TRANS/WP.29/GRE/2002/11  
25 January 2002

PROPOSAL FOR DRAFT AMENDMENTS TO REGULATION No. 98

(Headlamps with gas-discharge light sources)

Transmitted by the Expert from the Working Party "Brussels 1952" (GTB)

Figure C  
Primary Driving Beam

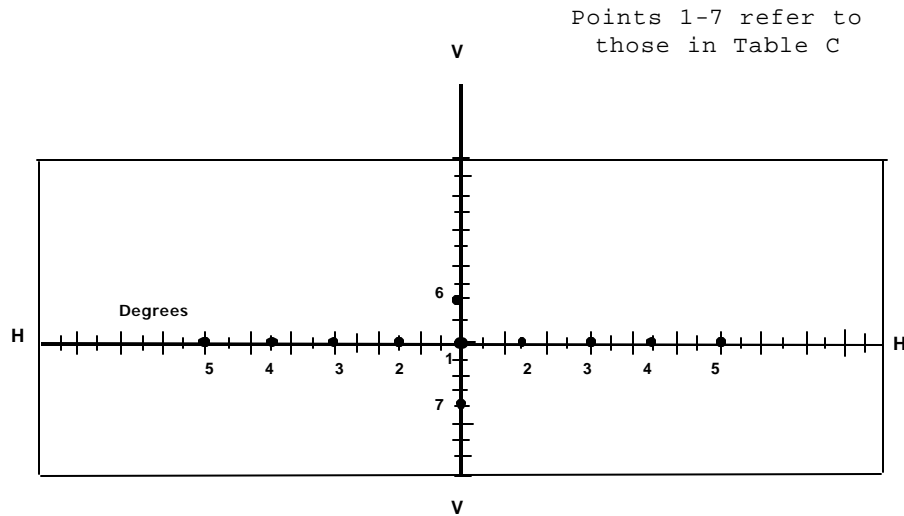
Annex 3, insert at the end Tables C and D and Figures C and D, to read as follows: 1/

1/ Note by the secretariat: Figure C (titled "Measuring points for illumination values") already exists in the current text of the Regulation. Should new Figure C replace it, or should new Figure C (and Table C?) be renamed?

"Table C - Primary driving beam headlamp

Refer to Figure C for details of test point positions

TEST POINT NUMBER	TEST POINT LOCATION	Required illumination in lux	
		Min.	Max.
1	H-V (1)	(1)	---
2	H-3R & 3L	40.0	---
3	H-6R & 6L	10.0	---
4	H-9R & 9L	3.84	---
5	H-12R & 12L	1.28	---
6	2U-V	1.92	---
7	4D-V	---	(2)
	MIN. LUMINOUS INTENSITY OF THE MAXIMUM	70.0	---
	MAX. LUMINOUS INTENSITY	---	180.0

- (1) Intensity at H-V shall be equal to or greater than 80 per cent of the maximum intensity in the beam pattern.
- (2) Intensity at 4D-V shall be equal to or less than 30 per cent of the maximum intensity in the beam pattern.
